BUFFALO RIVER WATERSHED ALLIANCE

Comments on Regulation 6 Revisions

The following are comments from the Buffalo River Watershed Alliance on proposed revisions to APC&EC Regulation 6 (Regulations for State Administration of the National Pollutant Discharge Elimination System (NPDES)), Markup Draft July, 2019.

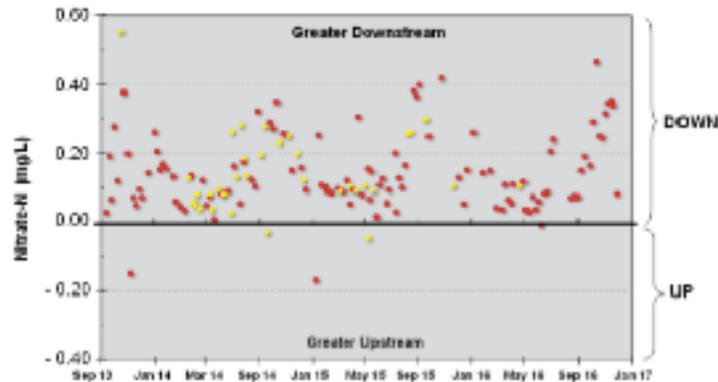
Nitrates are being measured by the *Big Creek Research and Extension Team* (BCRET) of the *University of Arkansas Division of Agriculture* both upstream and downstream of the facility and nearby spreading fields Figure 1.

“The data clearly indicate that the C&H CAFO is contributing swine waste pollution to adjacent public trust waters. The nitrate levels downstream from this CAFO commonly are levels that have been shown in other research to be toxic to sensitive aquatic life (Camargo et al. 2005, Guillette et al. 2005). The nitrate signal is stronger than the E. coli signal because nitrate does not adsorb to sediment particles and settle out (Stumm and Morgan 1996); instead, nitrate is highly soluble and is transported rapidly from swine CAFOs to receiving surface and groundwaters (Evans et al. 1984, Stone et al. 1998, Ham and DeSutter 2000, Mallin 2000, Krapac et al. 2002), the latter problem being exacerbated in underlying karst geology (Mellander et al. 2012, Knierim et al. 2015) which is characteristic of the region that includes the C&H CAFO (Hudson et al. 2001, 2011).”

“Nitrate-N concentration is significantly higher below the C&H facility and concentration declines as flow increases, suggesting transport is dominated by a subsurface process. This relationship, too, is stronger below C&H as the source.”
